UNITED STATES PATENT AND TRADEMARK OFFICE

APPLICATION NO.	FILING DATE	FIRST NAMED INVENTOR	ATTORNEY DOCKET NO.	CONFIRMATION NO.
09/516,753	03/01/2000	Gregory Pinchasik	2390/49701	3706

Office Action Summary

DETAILED ACTION

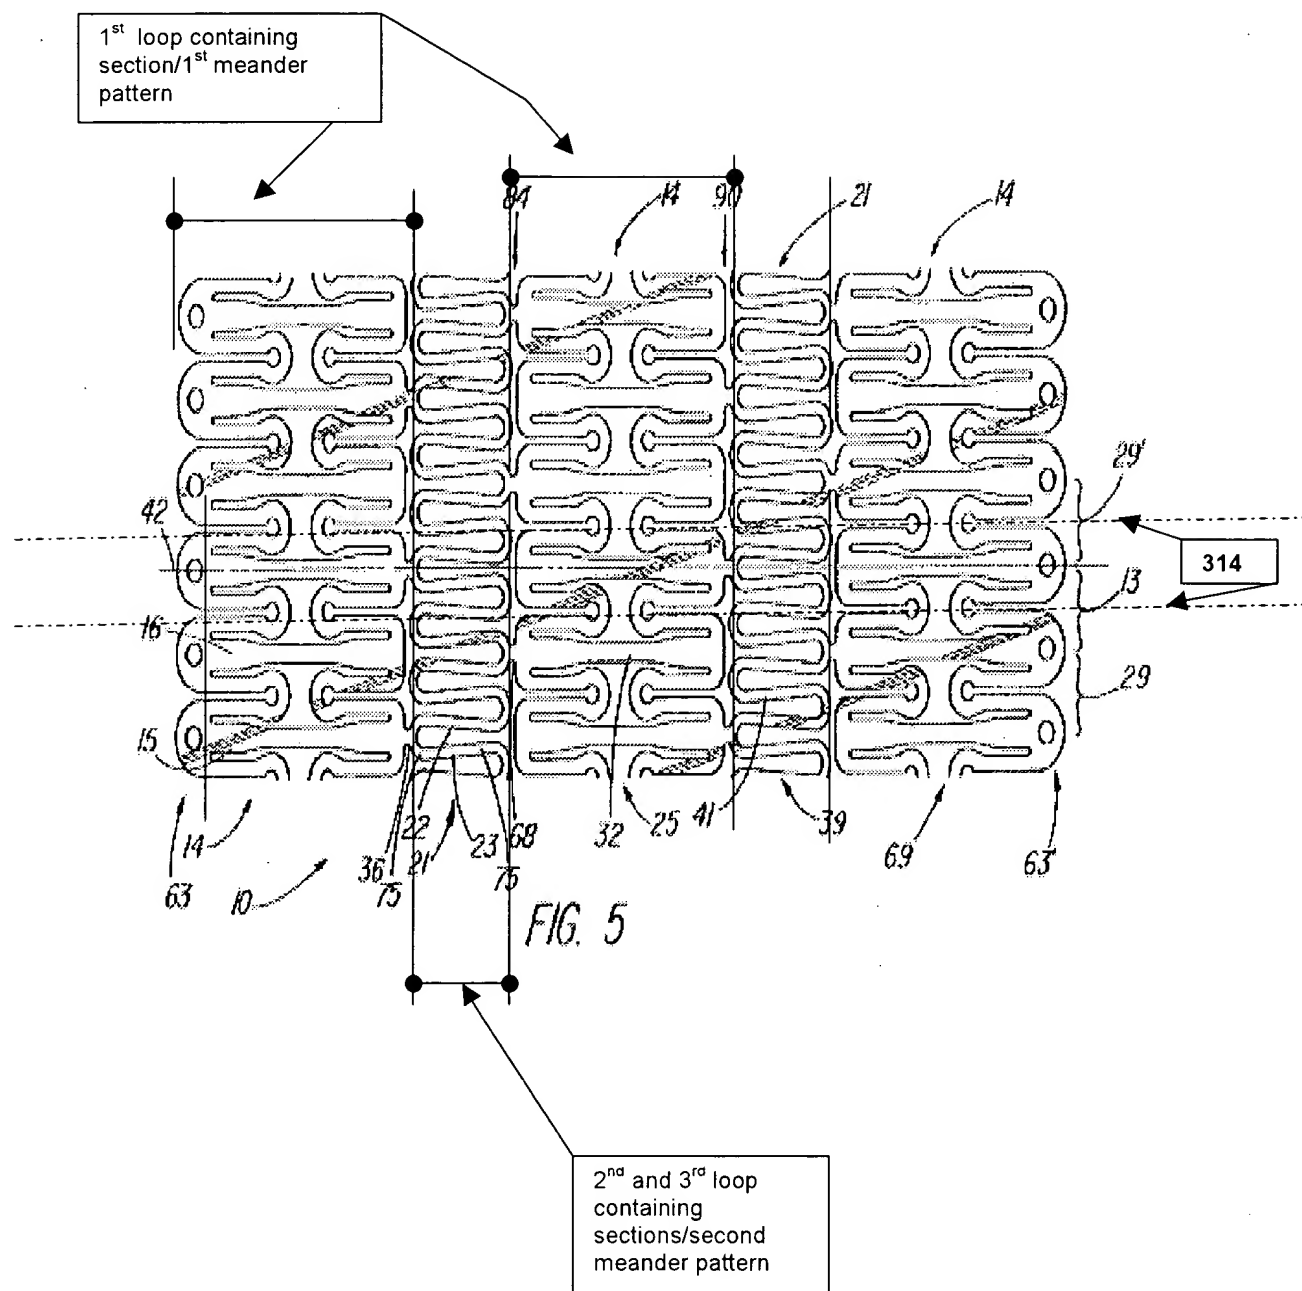
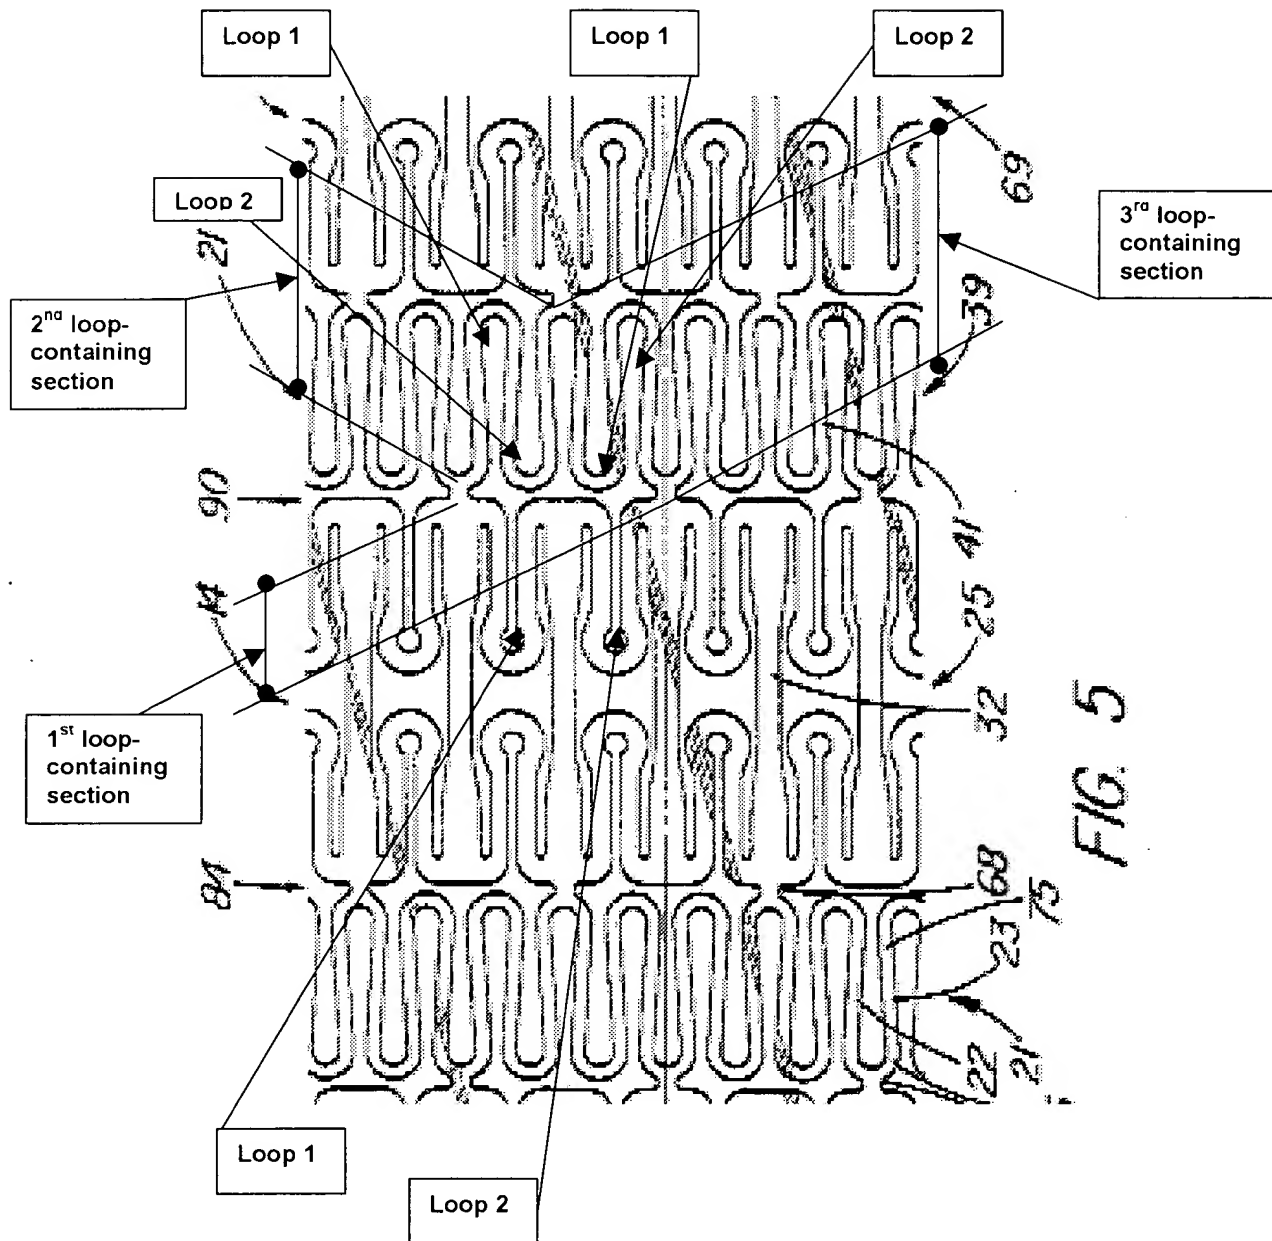
BERRY (Figs. 5 as shown below, for example) discloses a stent of stainless steel or nitinol:

As to claims 1-7, 9-10 and 45, BERRY (Fig. 5, page 4 this paper) discloses: 1st loop-containing section (highlighted in brown), 2nd loop-containing section (green) and 3rd loop-containing section (purple). The 1st, 2nd and 3rd loop-containing sections form triangular cells (highlighted in yellow), wherein each cell covers the same area. Notice that 1st loop-containing section has wider struts than the 2nd and 3rd loop-containing section, each loop-containing section has two loops, 1st and 2nd junction points are circumferential aligned.

As to claims 21-25, 27-28, 31-33, 37-46, and 48—50, BERRY (Fig. 5, page 3, this paper) discloses vertical meander/first meander pattern (highlighted in red) with

centerlines 301 and horizontal meander/second meander pattern (in green) with centerlines 314. The centerlines 301 of the vertical meander/first meander pattern are orthogonal to the centerlines 314 of the second/horizontal meander patterns. The vertical/first meander patterns include even vertical/first meander patterns 310e and odd vertical/first meander patterns 310o. The second/horizontal meander patterns include even horizontal/second meander patterns 312e and odd horizontal/second meander patterns 312o. Notice that the first/vertical meander patterns have two loops per period and the second/horizontal meander patterns have 4 loops per period as shown.

FIG. 5 (for reference of claims 67-92)

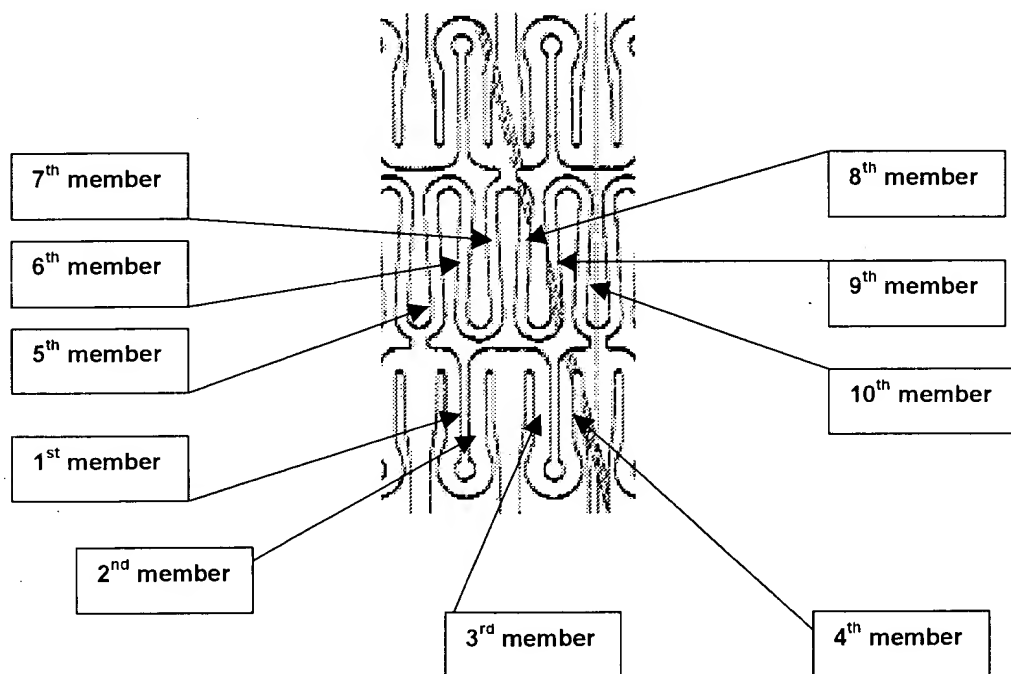
As to claims 67-70, 72-75, 77-81, 83-84, 86-88, and 90-91, BERRY (Fig. 5, this paper) discloses stent of stainless steel or nitinol having 1st, 2nd, 3rd, 4th, 5th, 6th, 7th, 8th, 9th, and 10th members which are interconnected as recited in the claims. The curved junction portions of the members define loops (shown in Fig. 5, page 6) as recited in the claims.

(For reference to claims 95-119)

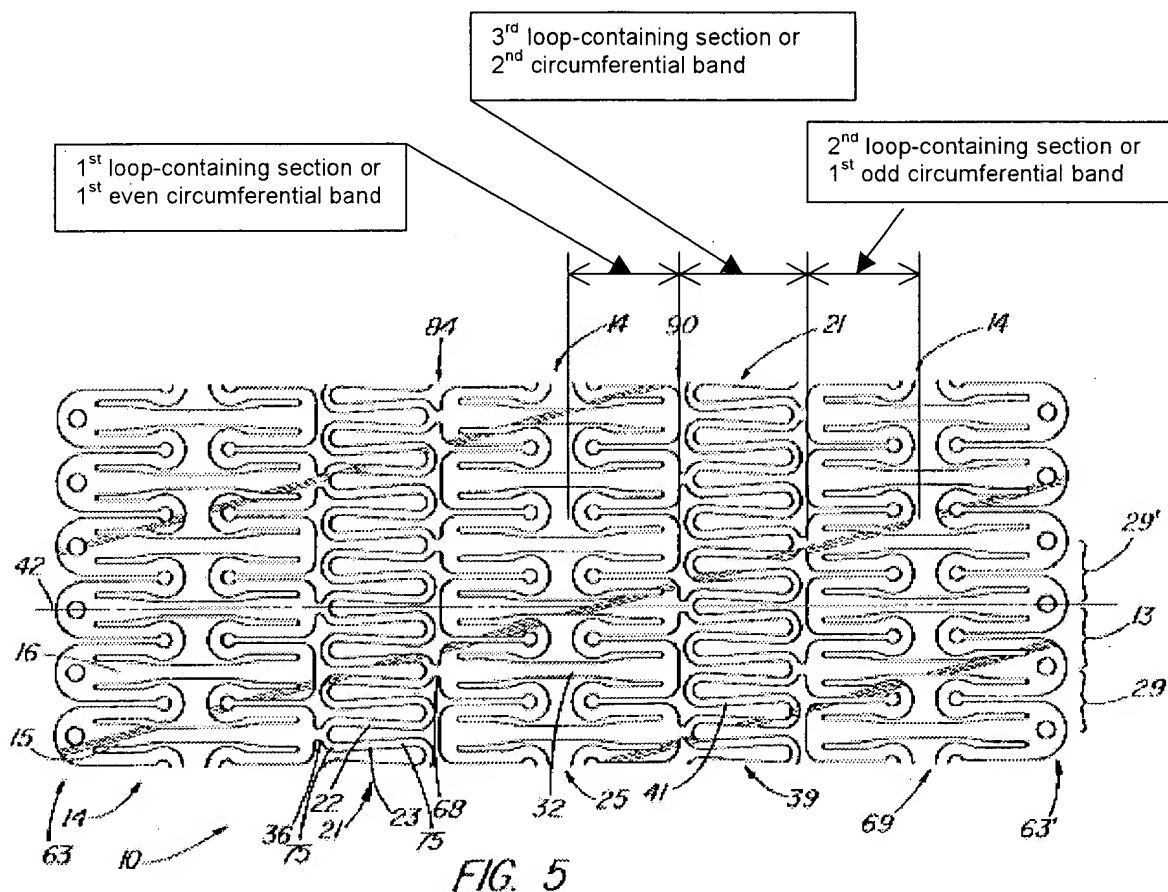
As to claims 95-104, 106-114, and 115-117, BEERY (Fig. 5, also Fig. 5 on page 7, this paper) discloses an even first loop containing section 301e/first circumferential band, an odd first loop containing section 301o/first circumferential band and third loop containing section/second circumferential band disposed between the first and second loop containing sections. The first or second loop containing sections (or the first circumferential band) and the third loop containing section (or the second circumferential band) defines loops as recited in the claims.
